NSLPP MEETING HELD ON 07/09/2022

ADDRESS/WARD: 15A Lower Wycombe Road, Neutral Bay (C)

APPLICATION No: DA 395/21/2

PROPOSAL: Modification of DA 395/21 to delete Condition C8(2).

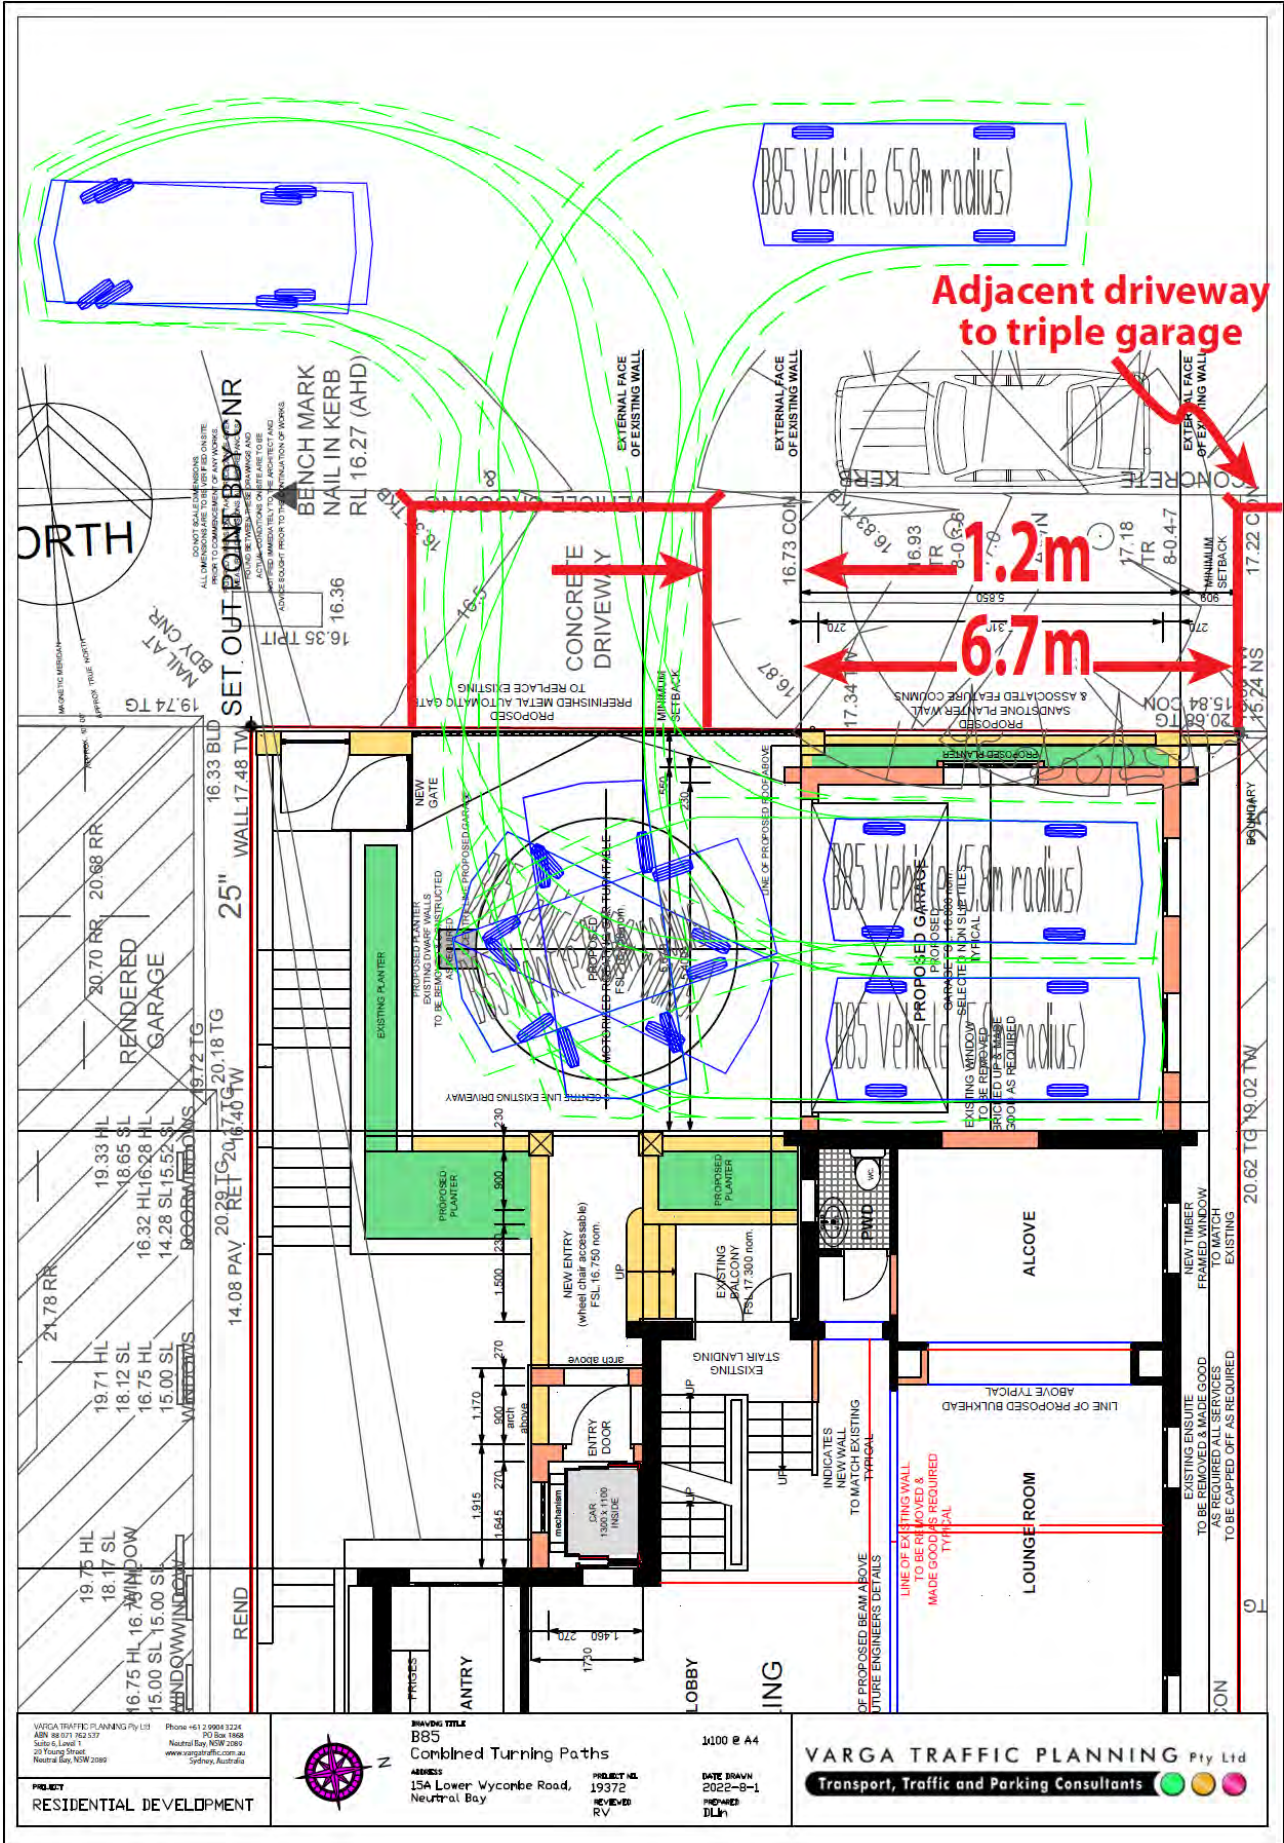
Reference to the image below confirms that there is one on street kerbside parking space 6.9m in length available between the subject driveway and the adjacent triple driveway located immediately to the east. Thus, narrowing the subject driveway by 1.2m would not achieve any increase in on-street car parking, and, at best, could only achieve a 1m² increase in existing green verge.

In the circumstances, it is therefore requested that the existing driveway be retained in its present configuration.

B85 TITLE
Combined Turning Paths
 ADDRESS
 15A Lower Wycombe Road,
 Neutral Bay

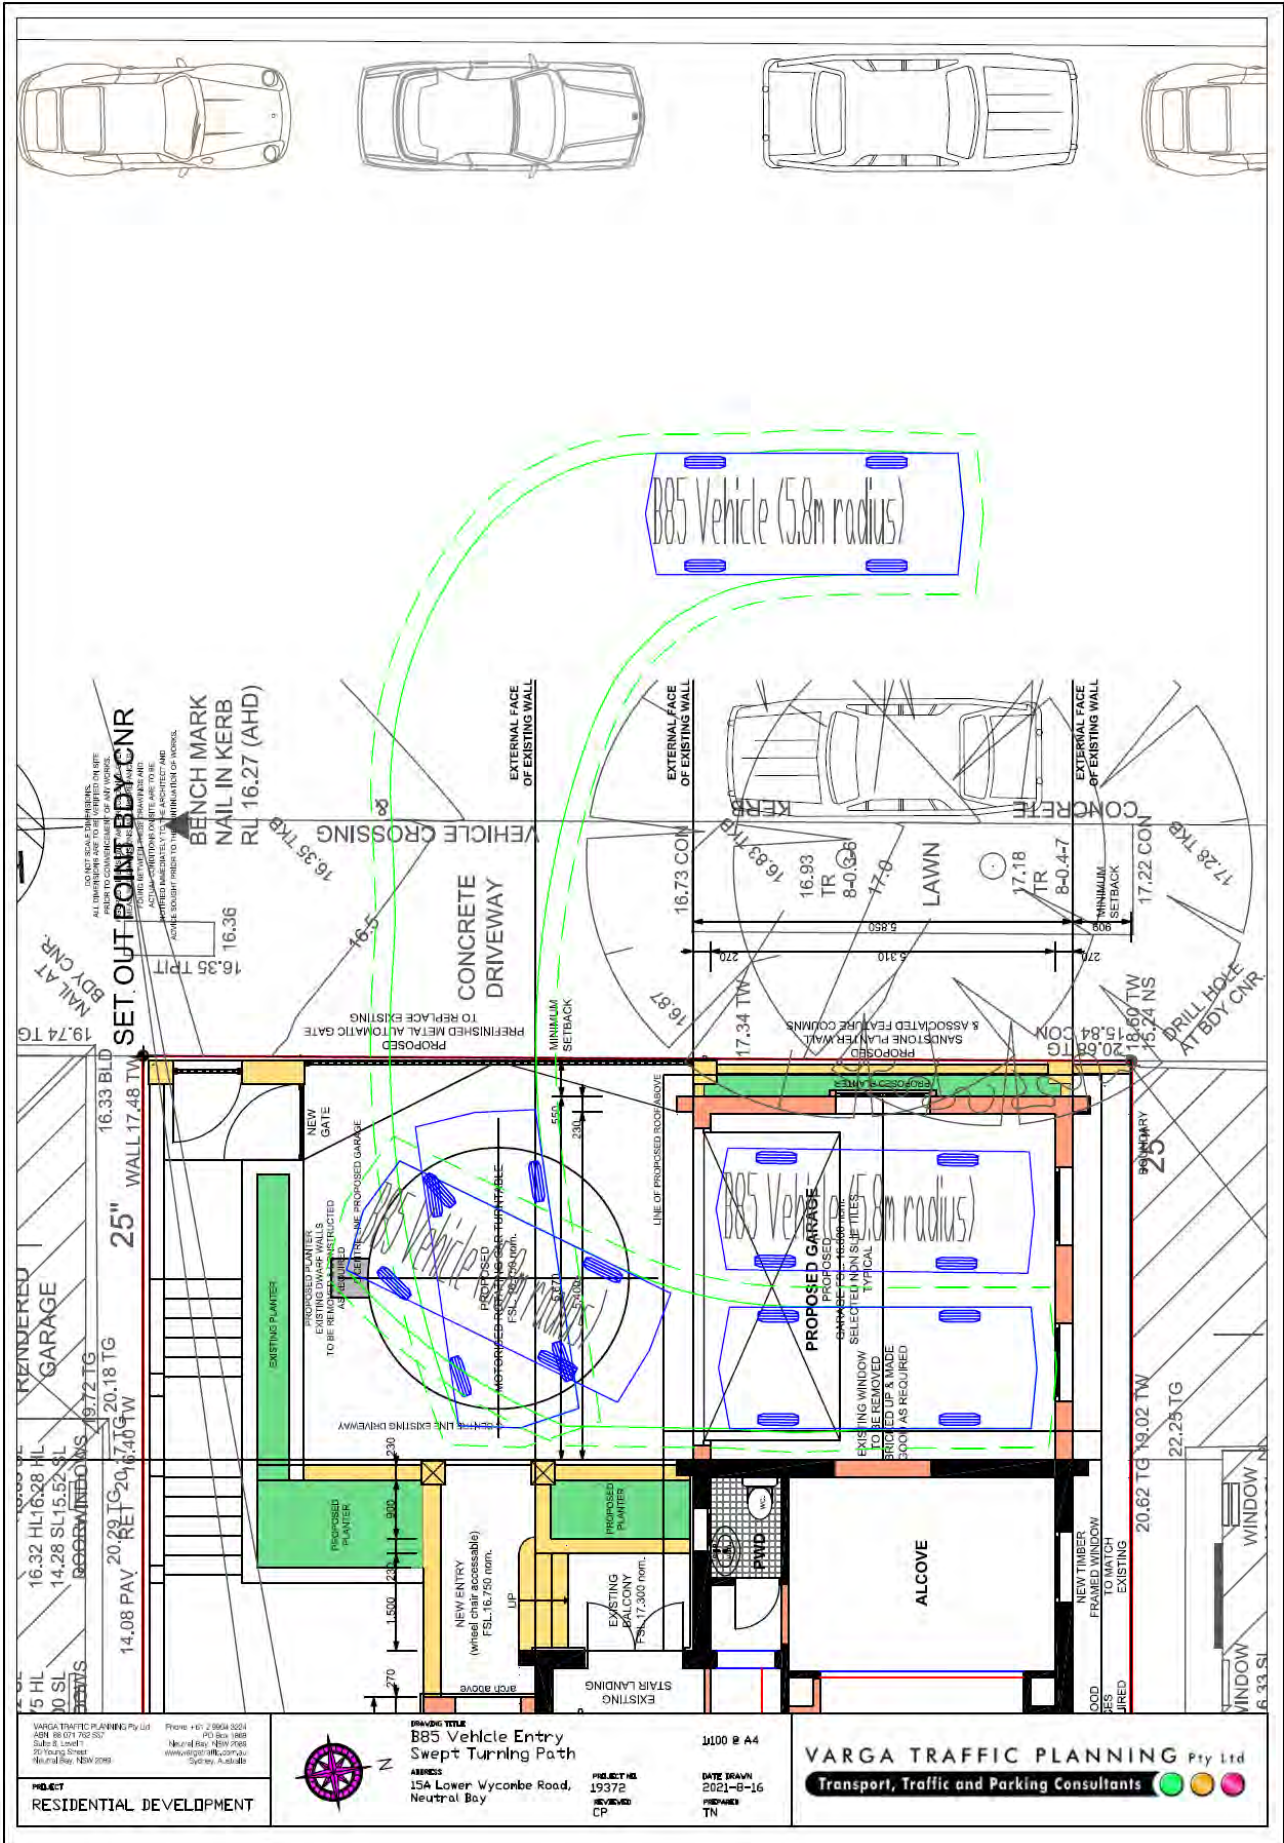
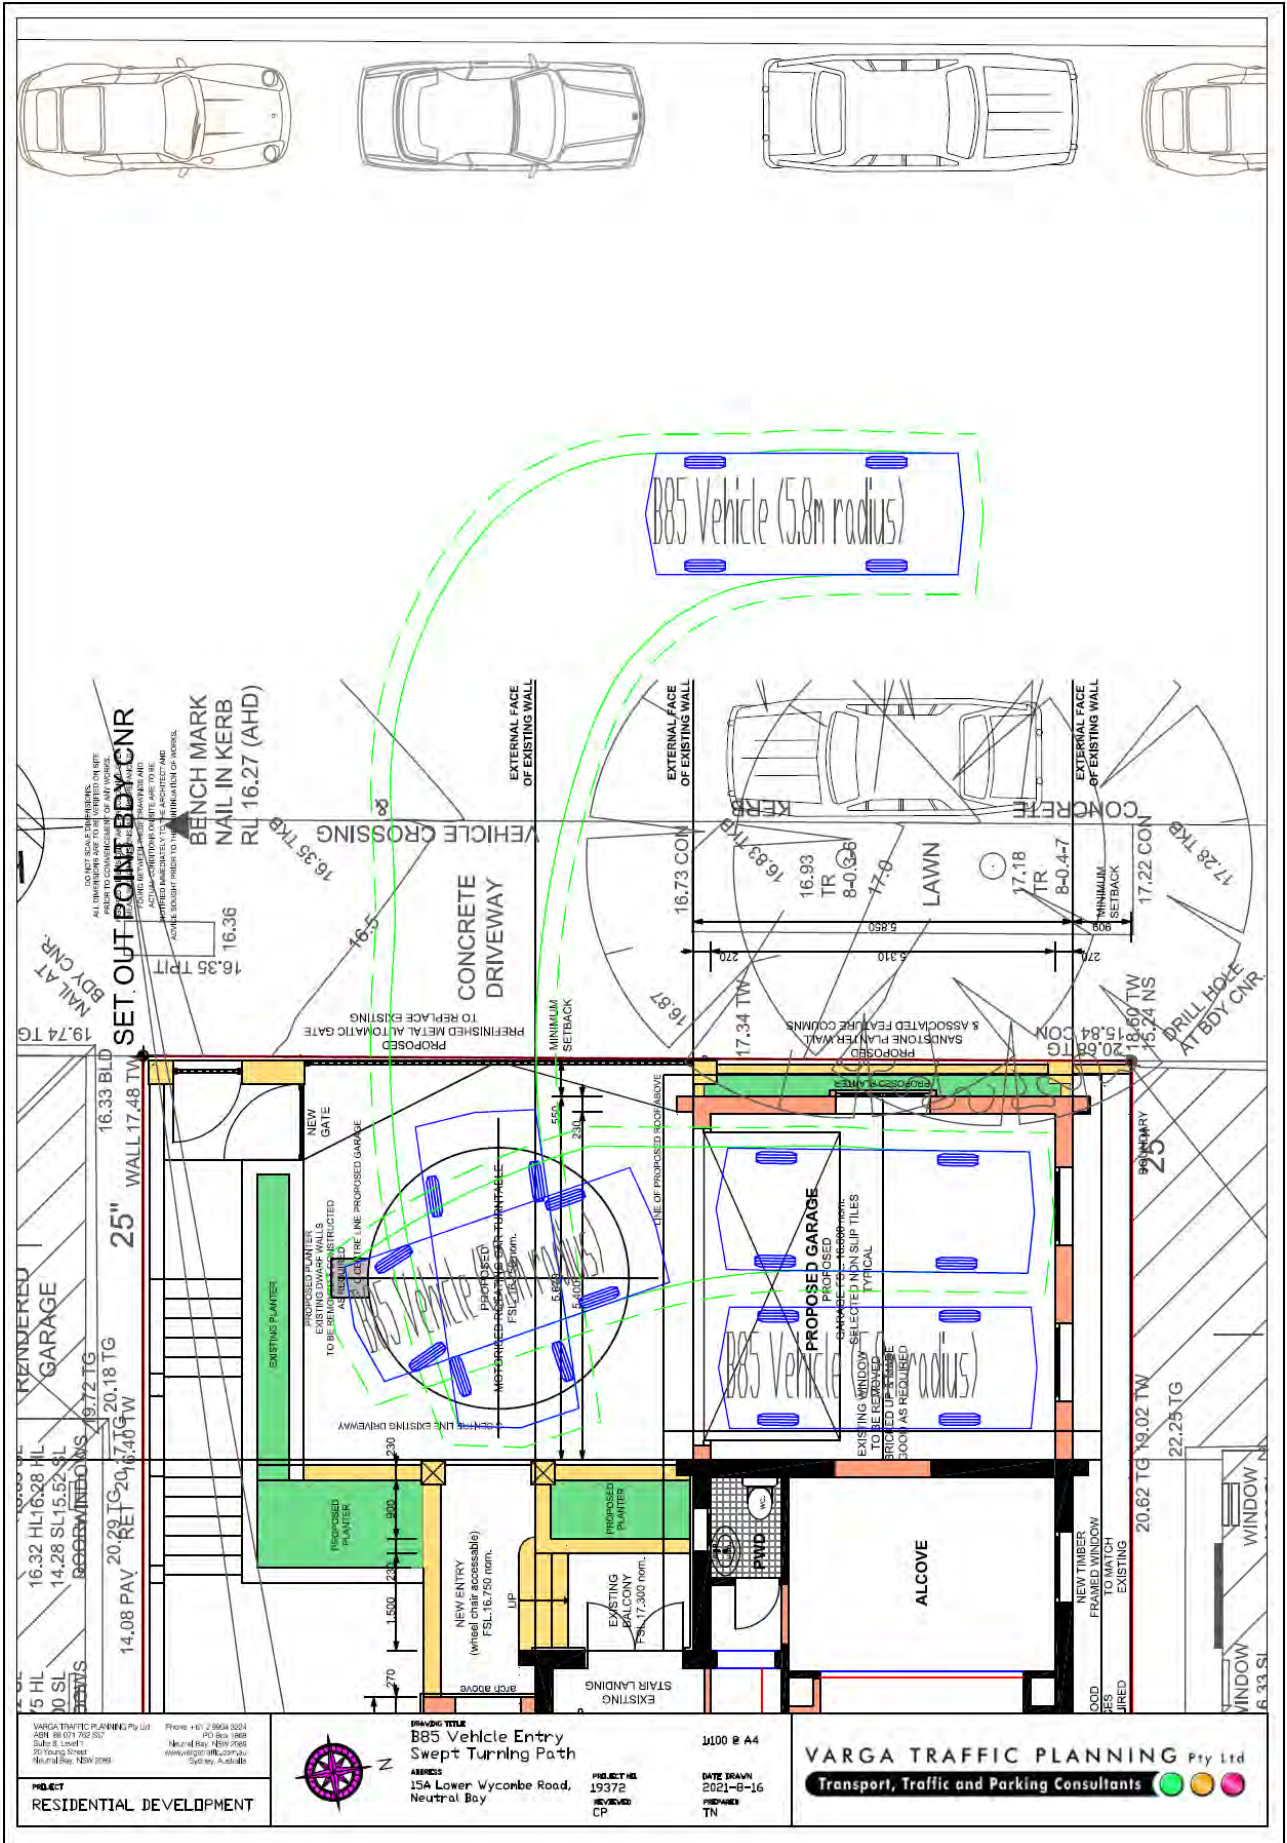
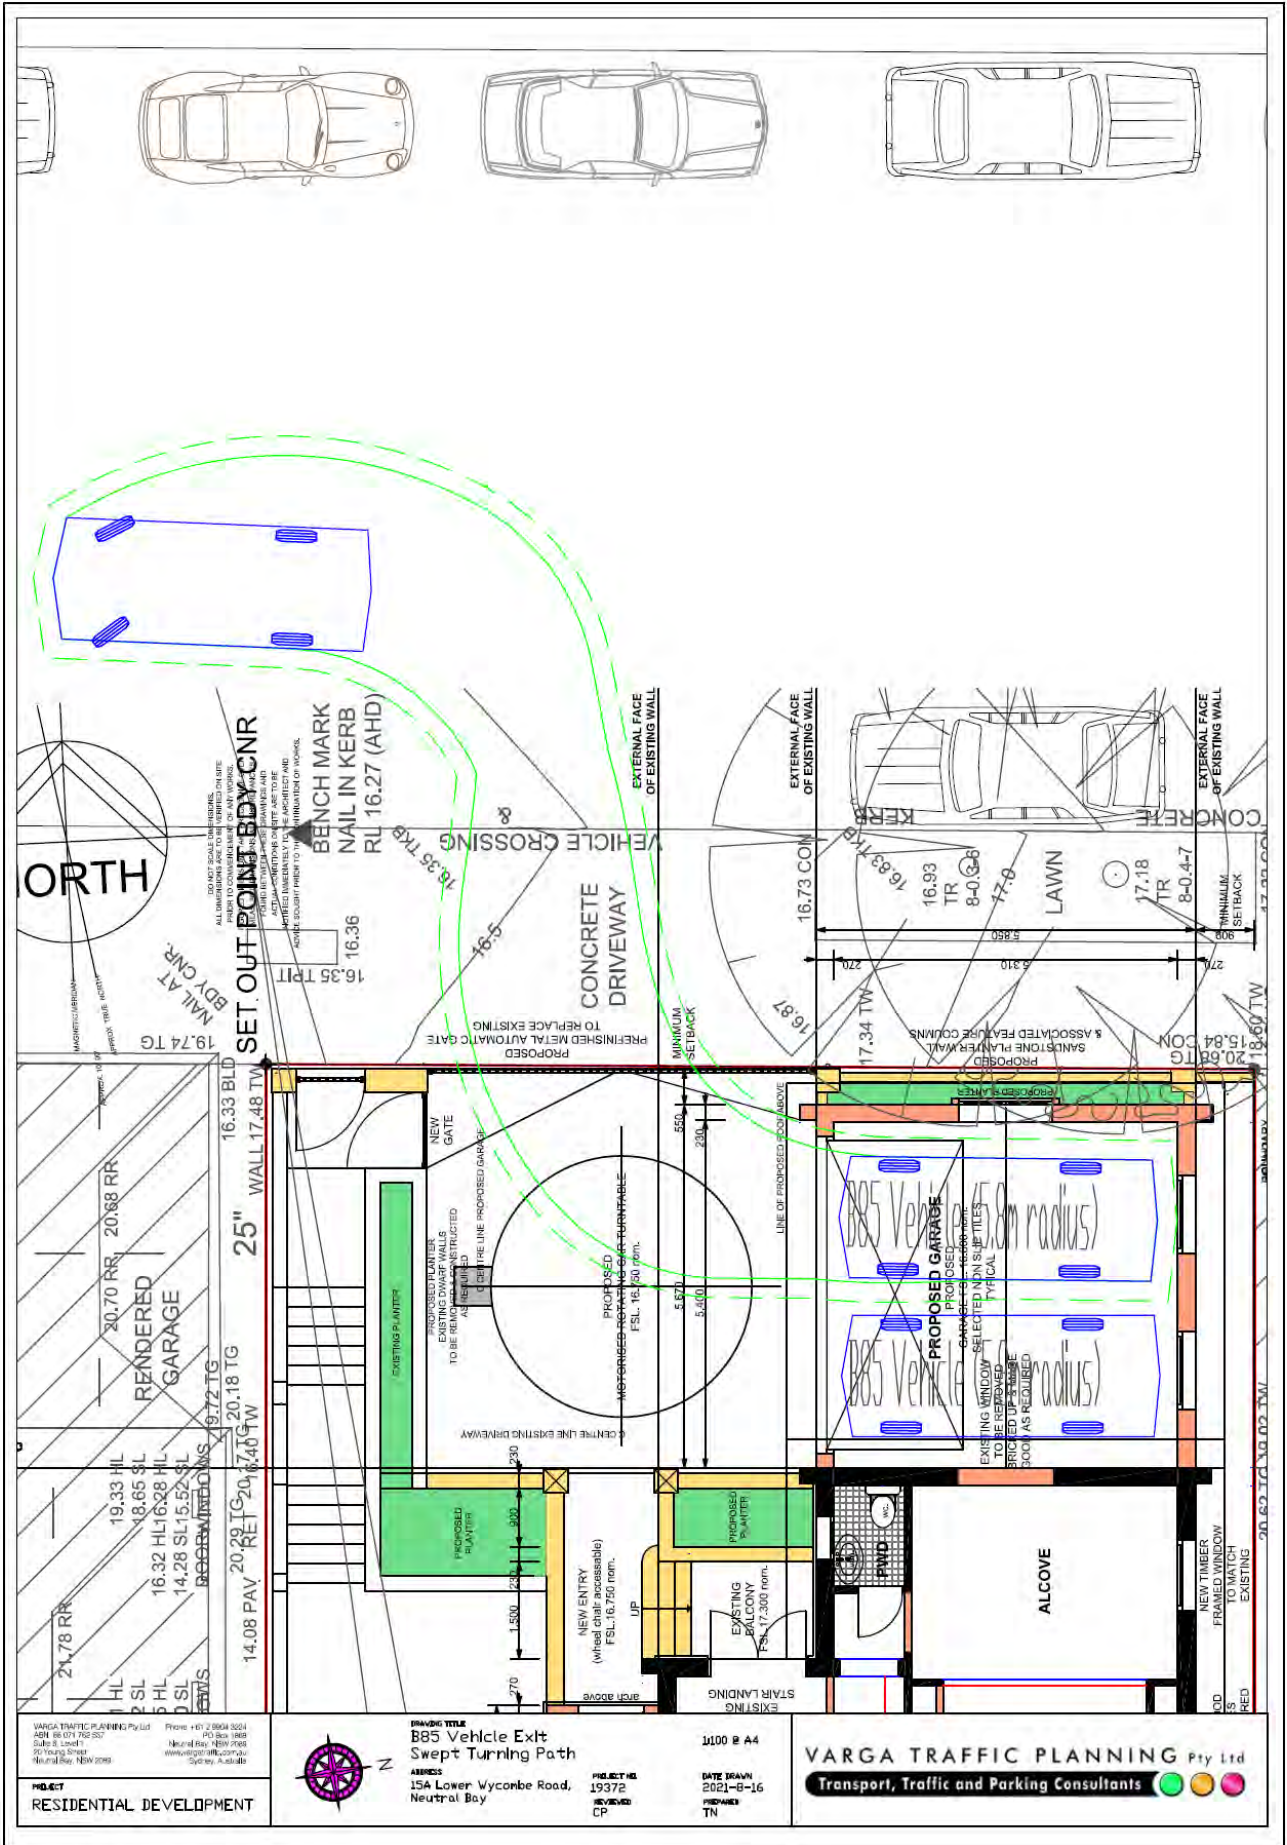
The proposed change is considered to be acceptable, as it has been demonstrated that a minimum width of 4.8m is required for the crossing and driveway to ensure sufficient turning paths to the approved parking spaces. This means that the driveway could only be narrowed by 1.2m on the eastern side, which would only create a minimal 1m² area of additional green verge, and would not result in any improvement in on-street parking. This minimal increase is compared to the works required to reduce an existing crossing that was unchanged in the original proposal considered under DA395/21.
